FINAL PLAT
REED'S COVE ADDITION
AN ADDITION TO WICHITA, SEDGWICK COUNTY, KANSAS

RE: SUB 2002-57- Final Plat of Reed's Cove Addition

RE: SUB 2002-57-- Final Plat of Reed's Cove Addition

CASE NUMBER: SUB 2002-57 -- REED'S COVE ADDITION

FINAL PLAT
REED'S COVE ADDITION
AN ADDITION TO WICHITA, SEDGWICK COUNTY, KANSAS

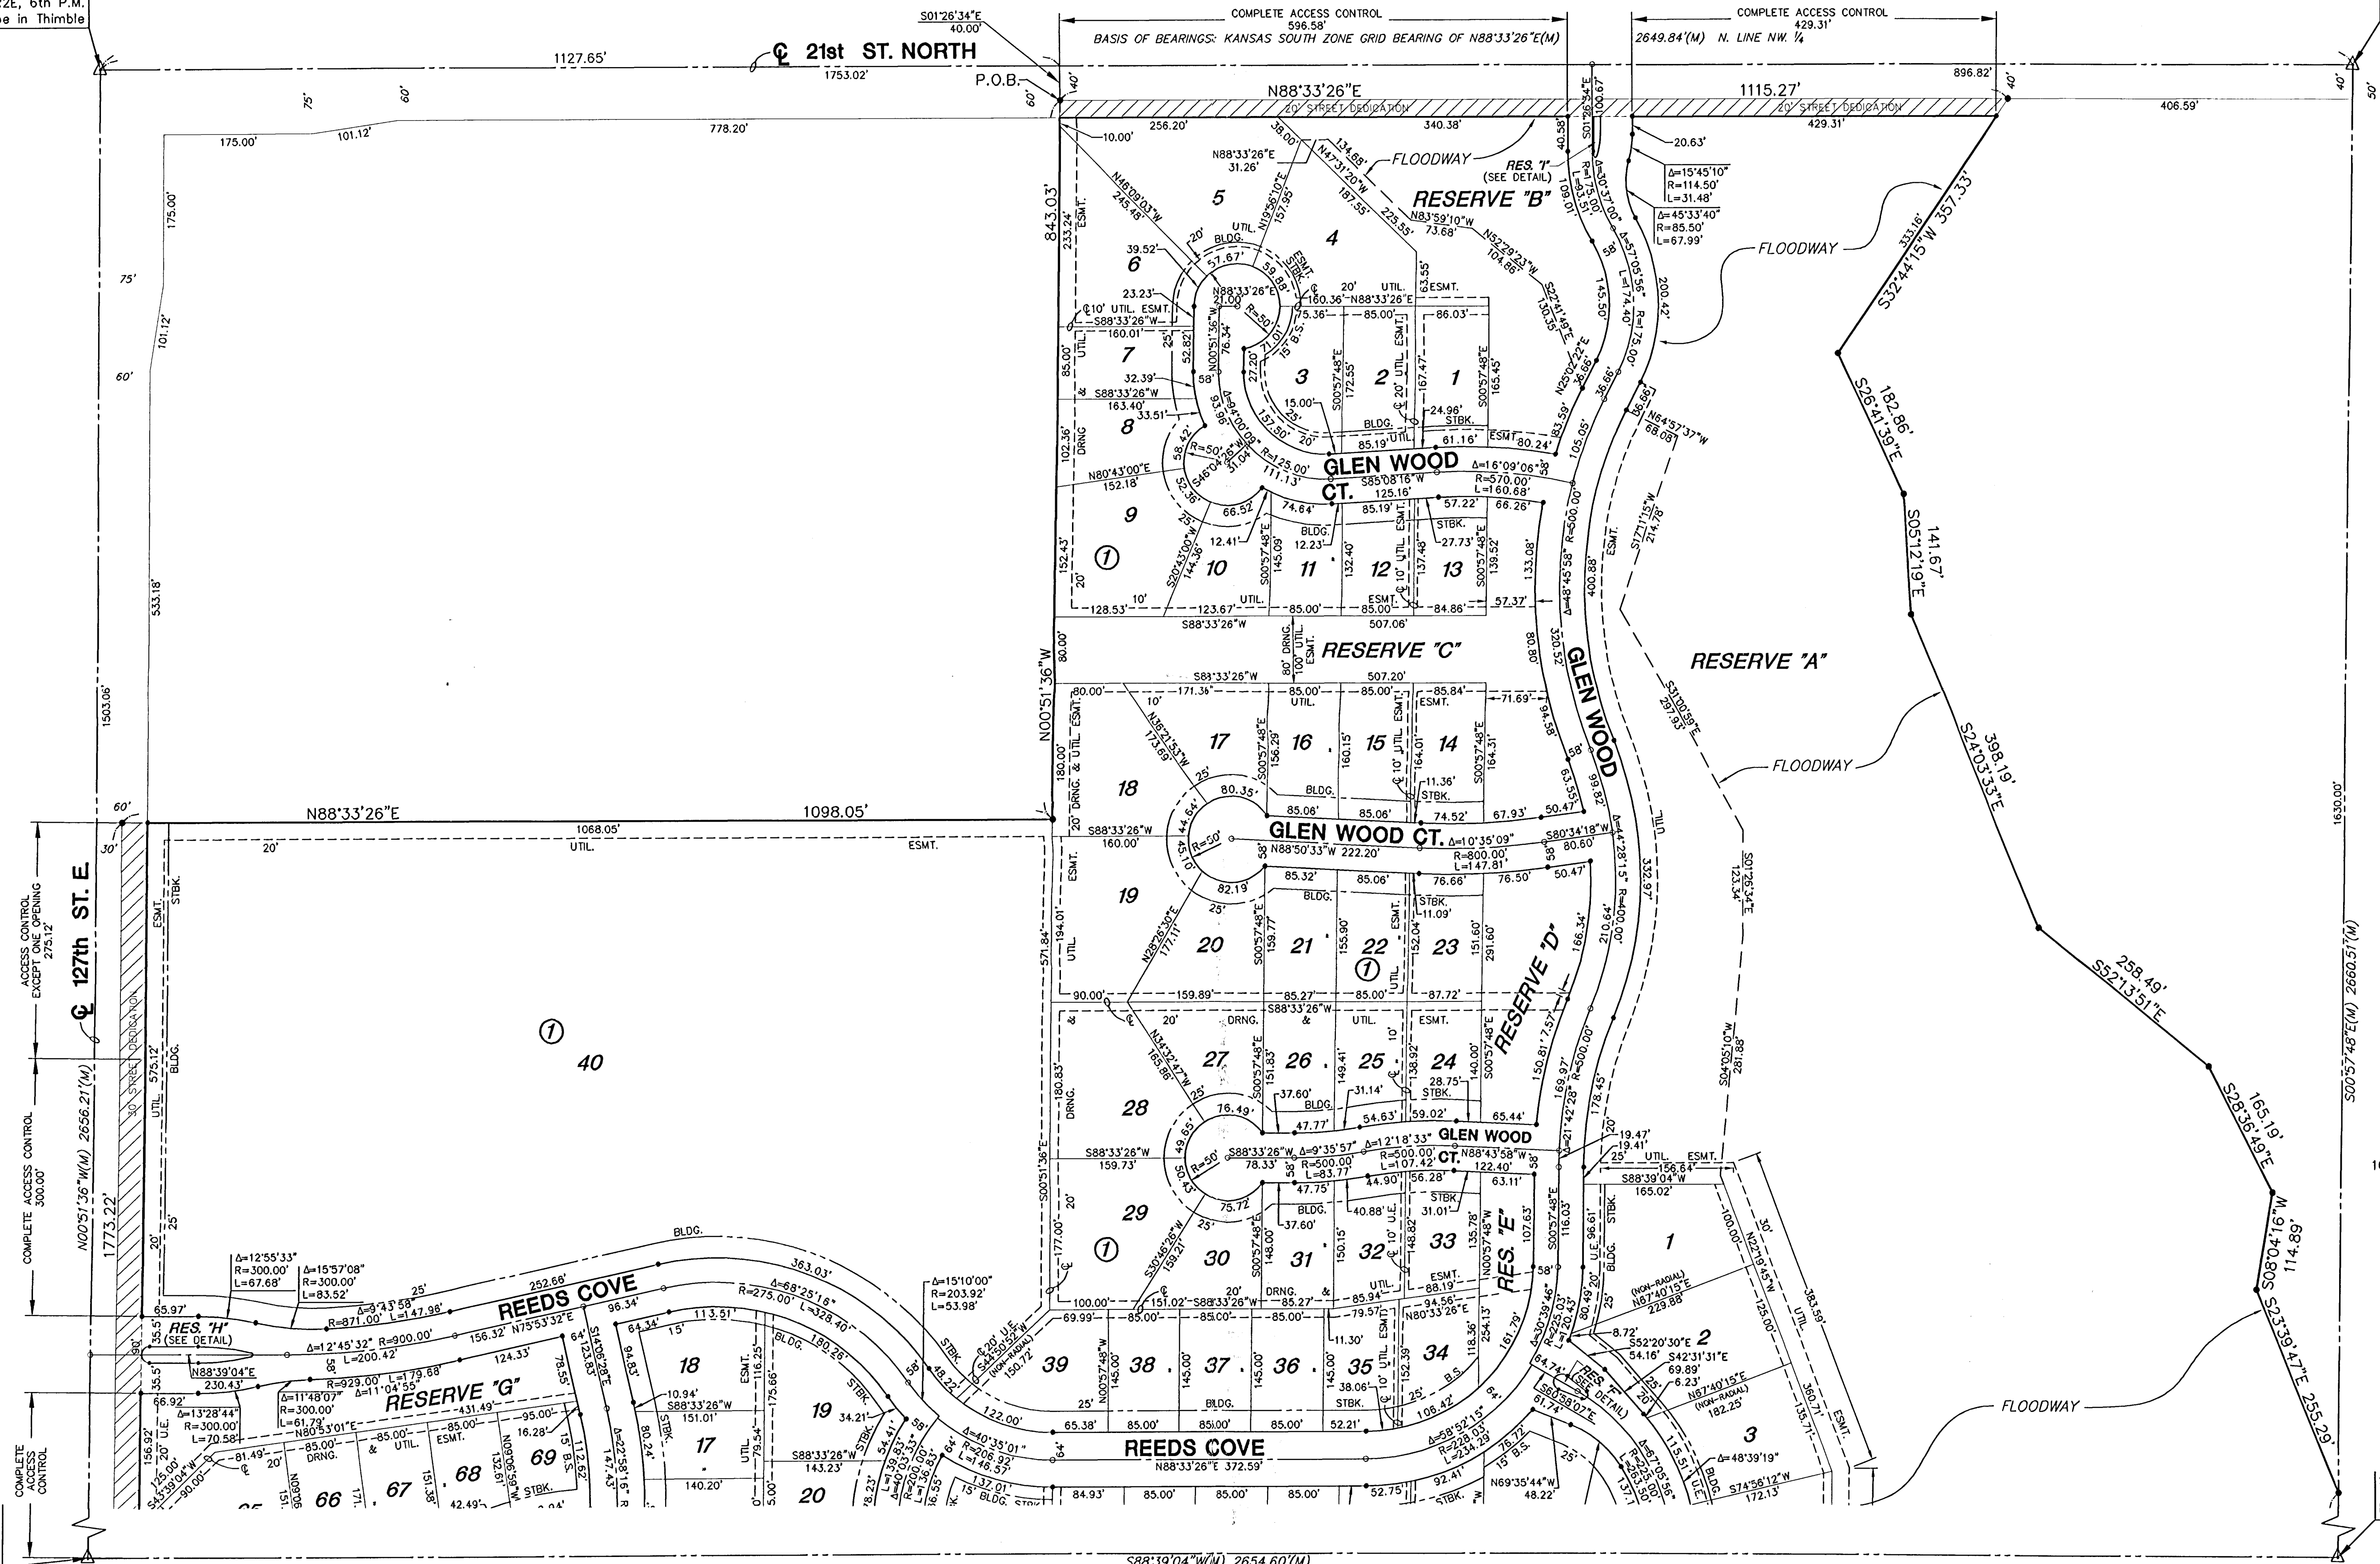
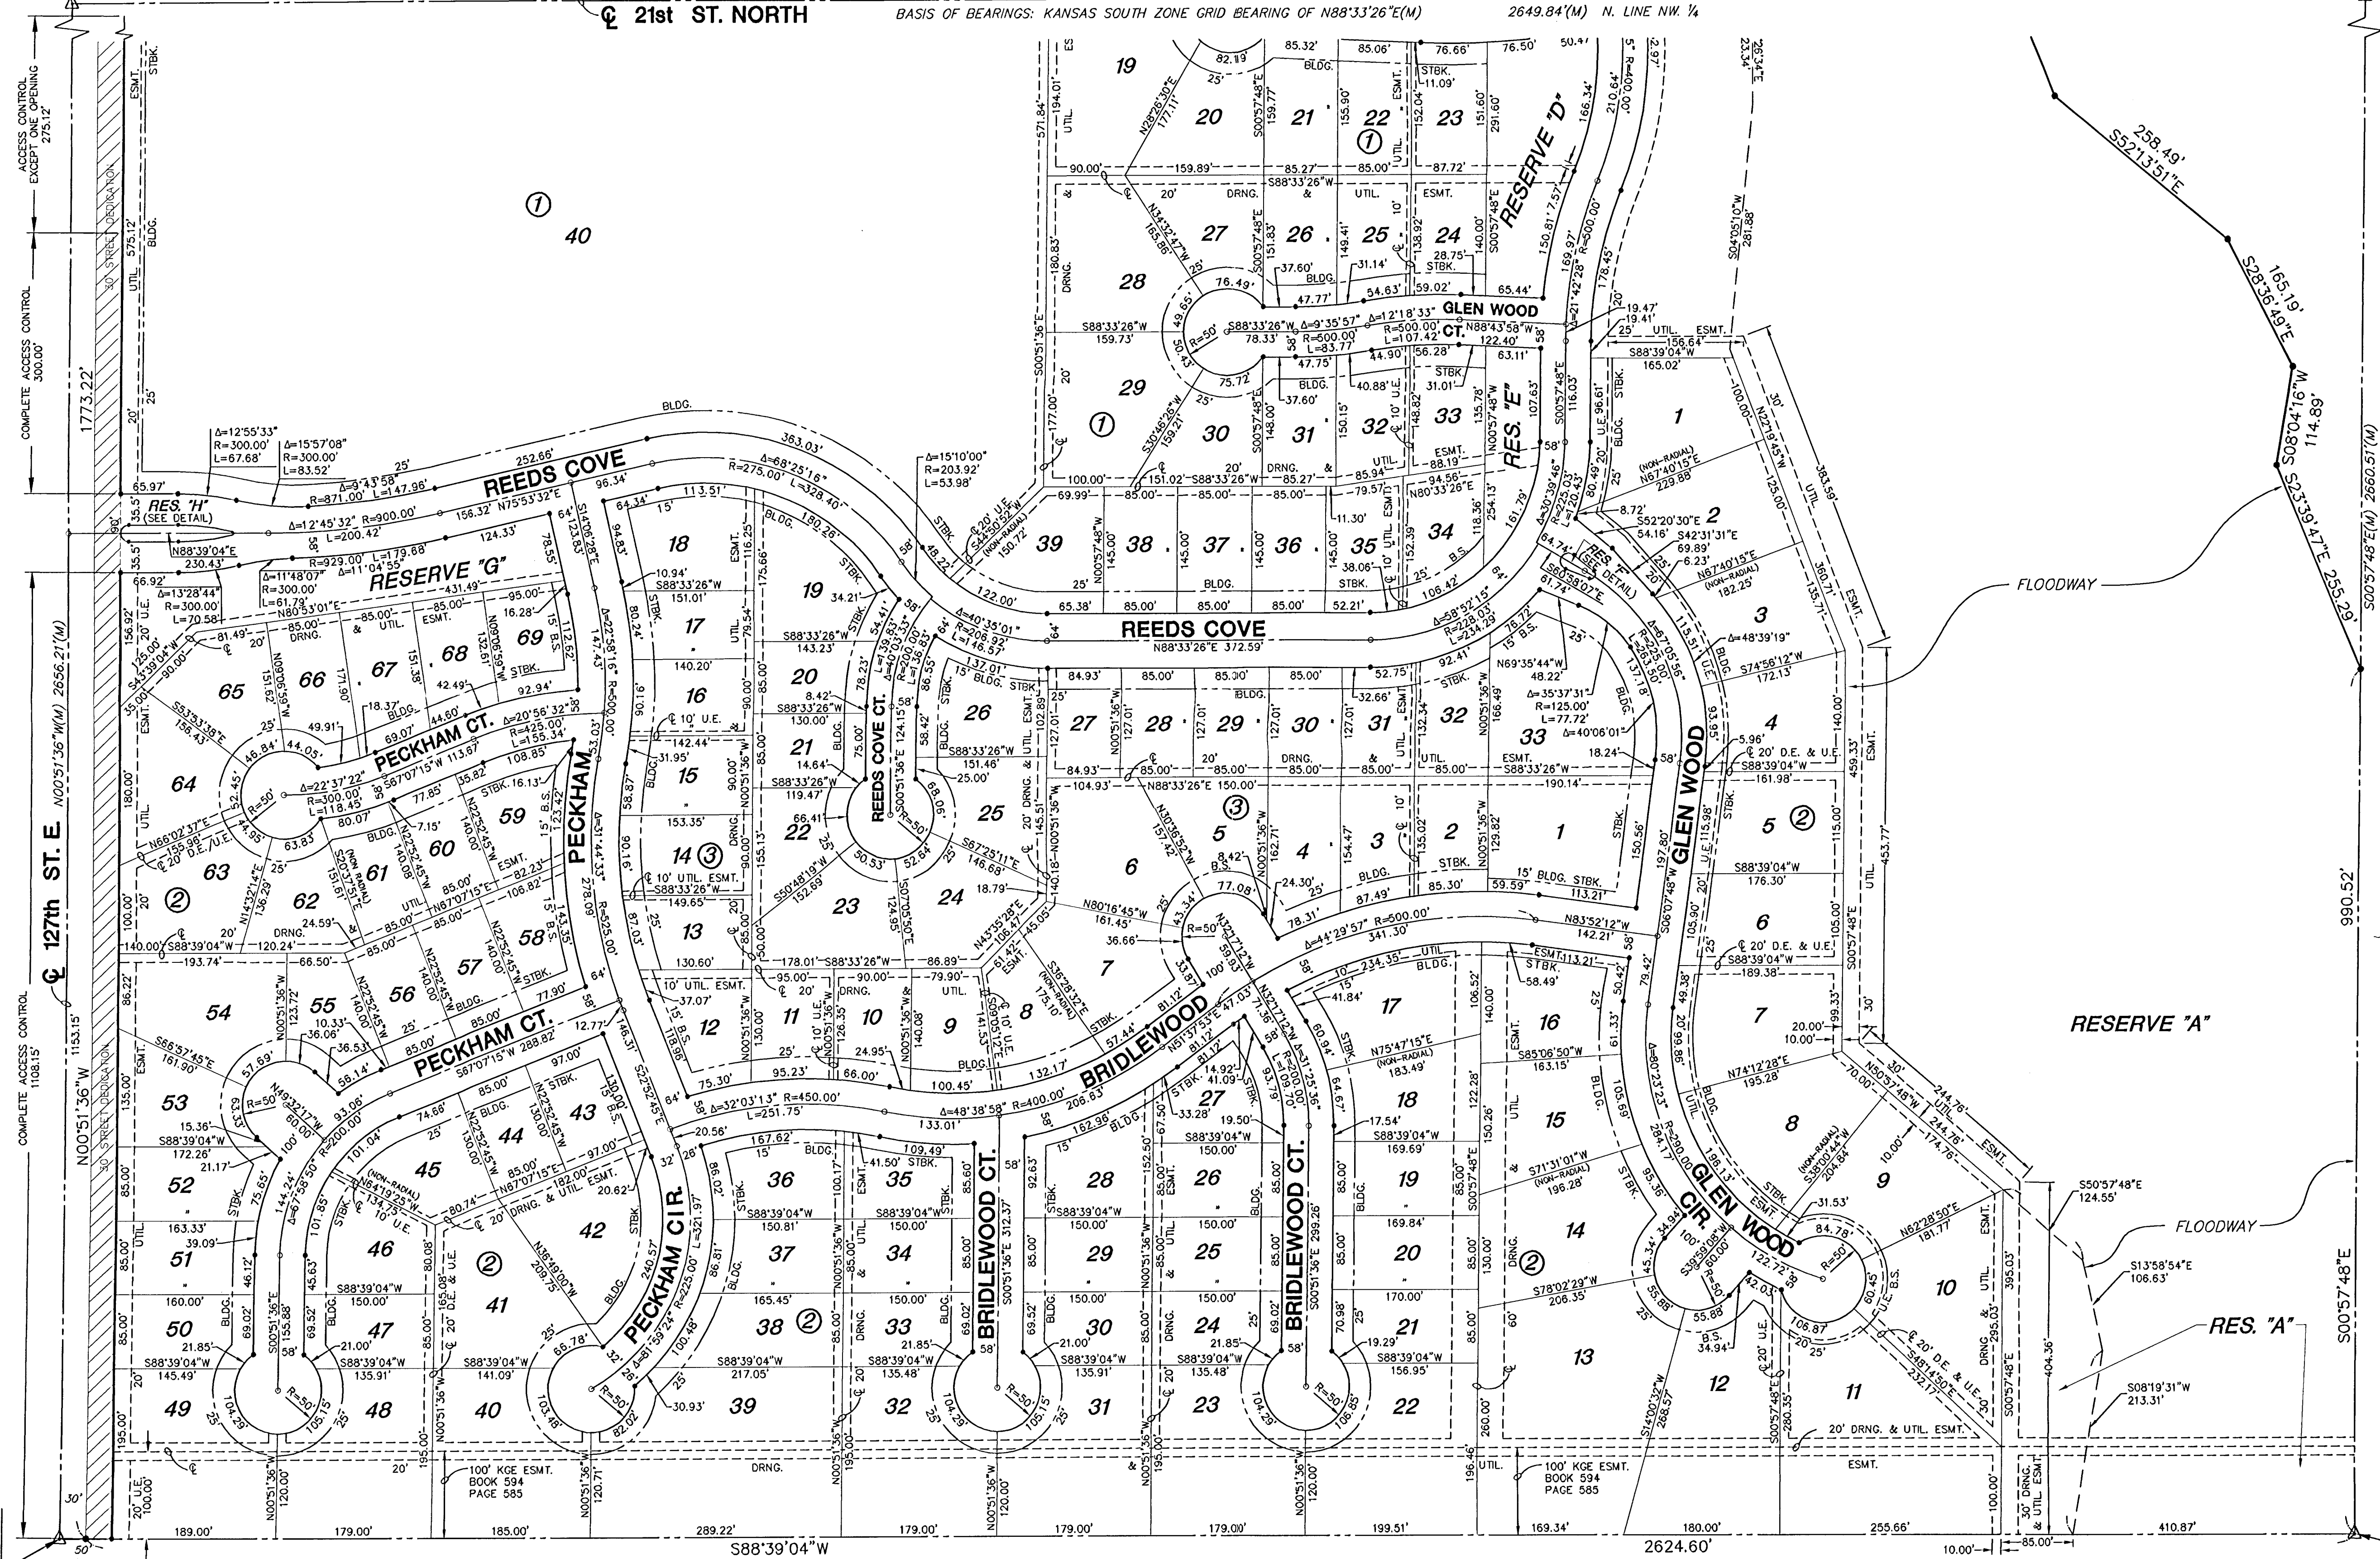
- E. County Engineering needs to see applicant's drainage plan for any effects on 21st St. County Engineering has noted drainage structures along the south property line. A drainage easement is needed. City Engineering has approved the drainage plan. A guarantee is needed.

- F. Complete access control has been platted along the site's frontage to perimeter streets. Traffic Engineering has approved an additional opening along 127th St. East for Lot 40, Block 1. This shall be labeled as "Access control except one opening".

- G. Traffic Engineering has approved all street widths. The 58-ft wide segment of Reed's Cove shall be limited to parking along one side of the street.

- H. Traffic Engineering has requested the deletion of Reserve H located at the entrance to the Addition along 127th St. East. The applicant has reduced the size of Reserve H which is acceptable to Traffic Engineering.

- L. The use of Reserves A and G for utilities located within platted easements should be referenced in the plat's text.
- M. As Reserve A includes a swimming pool, a site plan shall be submitted with the final plat, for review and approval by the Planning Director. The site plan shall include the information indicated in the Subdivision Regulations. Otherwise a conditional use and public hearing will be needed in the future.

- P. City Fire Department needs to comment on the street length of Woodbridge Ct at the southwestern corner of the site (650 feet). The Subdivision Regulations limit urban cul-de-sacs to 600 feet in length. The street length is approved.

- R. The City Fire Department/GIS needs to comment on the plat's street names. "Reeds Cove" needs to be changed to "Reeds Cove" A new name is needed for Reeds Landing. The Subdivision Committee has approved "Reeds Cove".

- S. "13th St. North" shall be revised to "21st St. North".
- T. The Applicant is reminded that a platting binder is required with the final plat. Approval of this plat will be subject to submittal of this binder and any relevant conditions found by such a review.

- CC. The representatives from the utility companies should be prepared to comment on the need for any additional utility easements to be platted on this property. **Southwestern Bell has requested additional easements.**
